TECHNICAL & SAFETY COMMITTEE

INTERNATIONAL PARACHUTING COMMISSION (FAI)

Technical & Safety Information Notice No.	5/2013 VELOCITY SPORTS EQUIPMENT SERVICE BULLETIN SERVICE BULLETIN VSESB001, REV 0, RE MAIN RISER LOCKING LOOP WEAR. W.N. 47
Date of Issue	12 July 2013
Subject Matter and Applicability	<p>VELOCITY SPORTS EQUIPMENT SERVICE BULLETIN VSESB001, REV 0, RE MAIN RISER LOCKING LOOP WEAR.</p> <p>DATE: June 01, 2013</p> <p>SERVICE BULLETIN VSESB001, REV 0.</p> <p>SUBJECT: MAIN RISER, LOCKING LOOP WEAR</p> <p>STATUS: MANDATORY INSPECTION</p> <p>IDENTIFICATION: All main risers manufactured by Velocity Sports Equipment(VSE)</p> <p>BACKGROUND: Several main risers have been found in the field with frayed/partially cut locking loops (the white type 2A loop). The amount and location of damage on the loops varies, leading VSE to conclude there may be several contributing factors. A loop failure can result in an out of sequence main release and reserve deployment which can cause an entanglement. Due to this danger, VSE feels all main risers should be inspected according to the following Service Bulletin.</p> <p>Who can inspect: Any FAA certified senior or master parachute rigger or fore

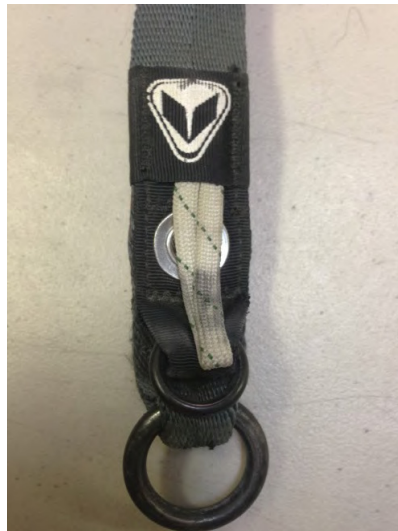
The following pictures show locking loops with normal wear.

The following pictures show locking loops with damage; heavily frayed and partially cut.

<p>RESOLUTION:</p> <p>If the loop shows signs of damage, the rig should not be jumped and VSE should be contacted for further instructions. VSE may also ask for additional information to help determine the root cause and most effective repair. At minimum, VSE will need 2-4 photos, one of each riser loop and one of each housing grommet. Please have these available to send to VSE when you call in. In most cases, once the root cause is determined, VSE will provide a parts kit which can be installed by an FAA certified senior or master parachute rigger or foreign equivalent using the Housing Replacement Procedure provided at the end of this service bulletin. In certain cases, VSE will require the rig be returned to VSE for further inspection and repair.</p> <p>If the loop shows normal wear, the rig can continue to be jumped and no immediate repair is needed.</p> <p>VSE recommends periodic checks of the locking loops moving forward for all rigs. Minimally, these checks should be completed every three (3) months during the periodic maintenance of the 3 ring release system.</p>

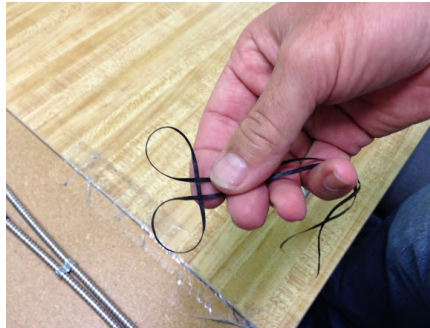
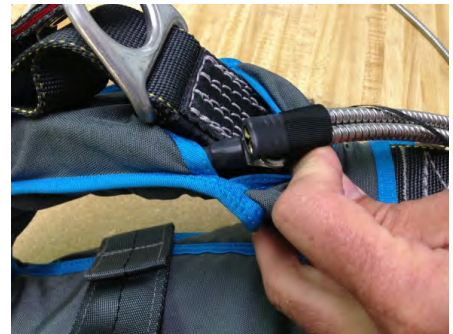
3. Attach the tack cord to both sets of housings

a. Tie tack cord on new housings using the double loops shown (end with both housings shrink wrapped)

b. Tie tack cord end of old housing (end with amp connector/grommet)

c. Ensure the tack cord is secure so it doesn't come undone inside the yoke
